PLANNING COMMISSION AGENDA

Title: Final Site Plan - 940 North 1250 West - Hogan Steel Fabrication & Cabinet Shop - ADMINISTRATIVE DECISION

APPLICATION: REQUEST FOR FINAL SITE PLAN APPROVAL

FINAL SITE PLAN SUBMITTAL REVIEW – CZC 12.21.110(e)

SITE PLAN - ELECTRICAL

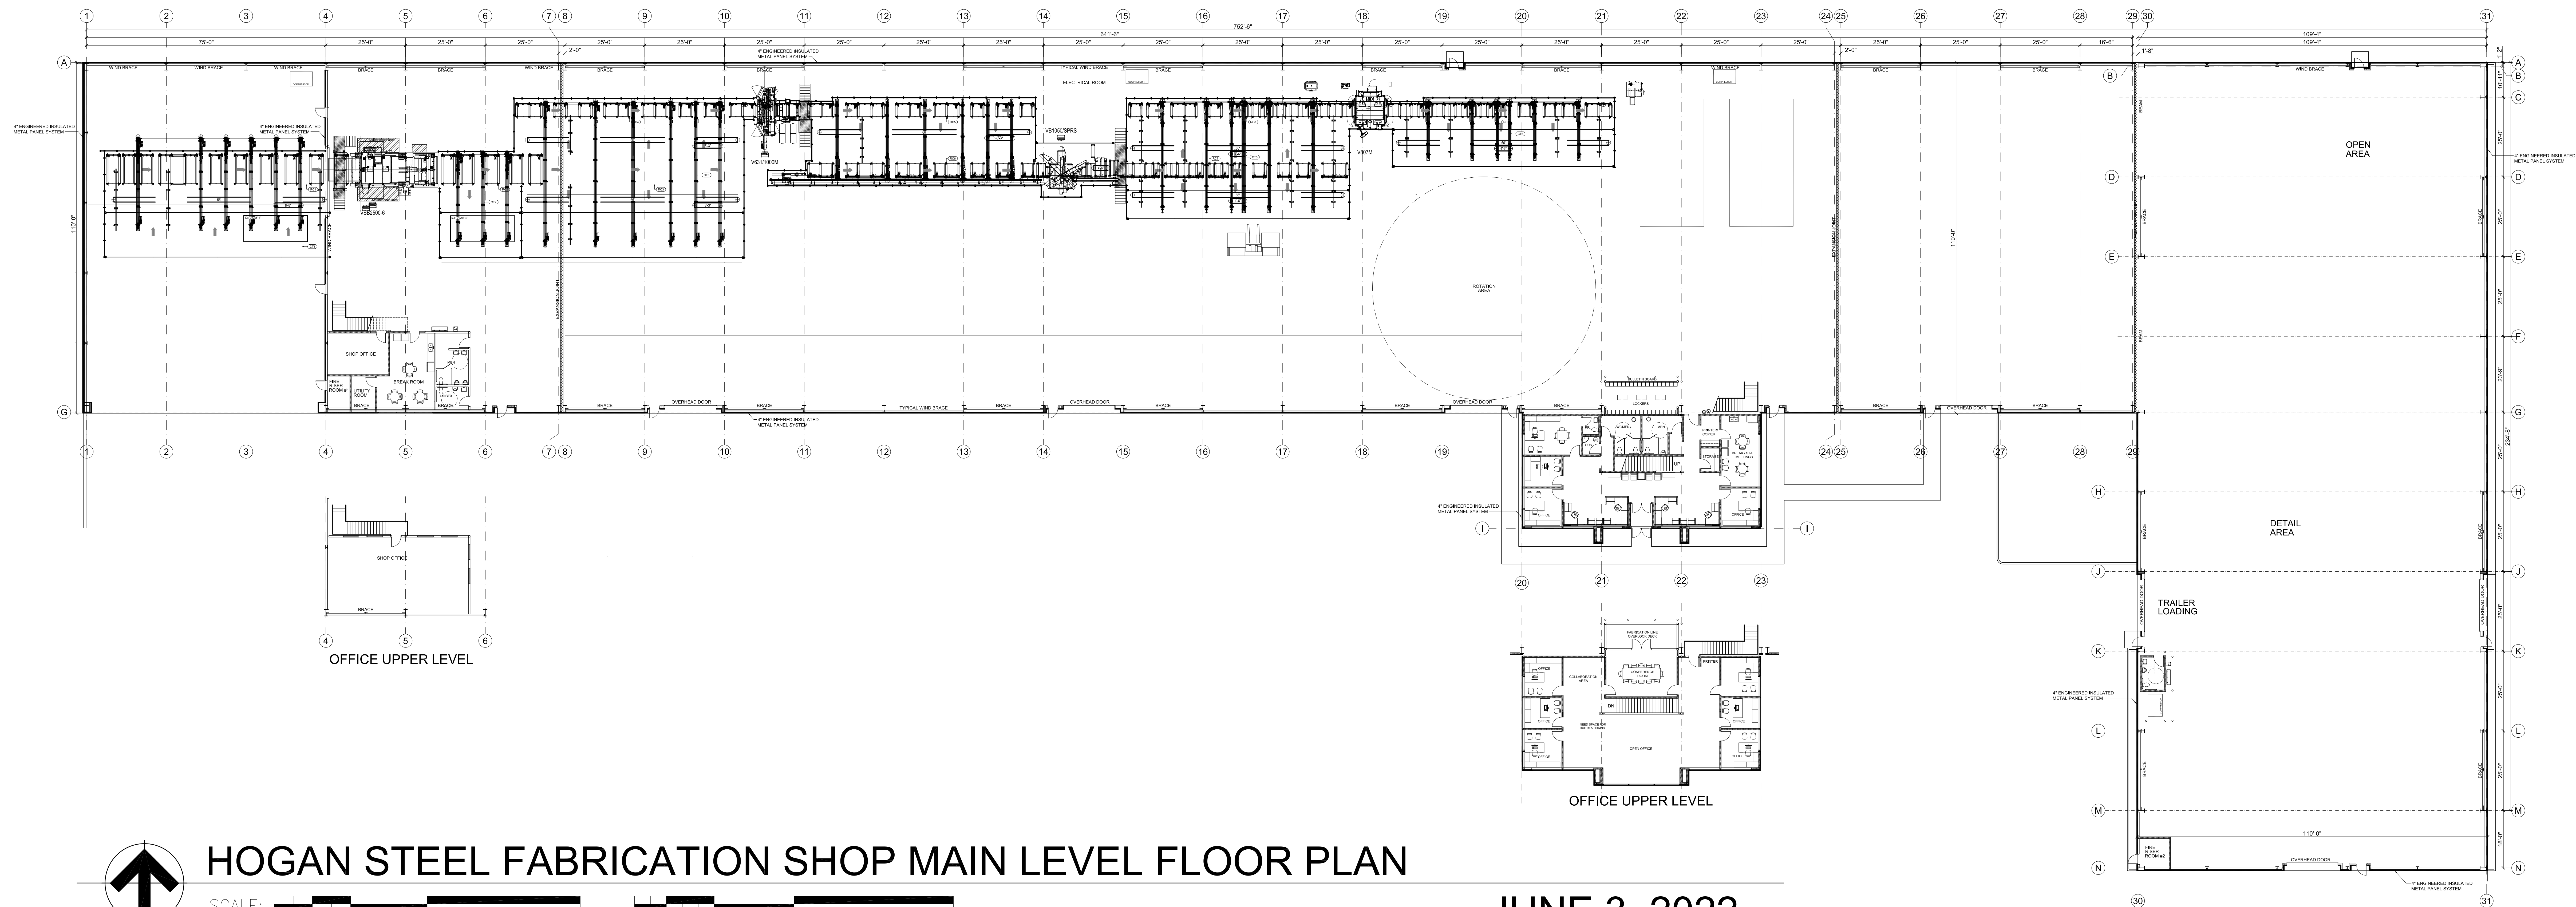
- **Outdoor Lighting 12-54** – The Final Site Plan submittal appears to be compliant with the ordinance. However, **the required shielding may need verification.**
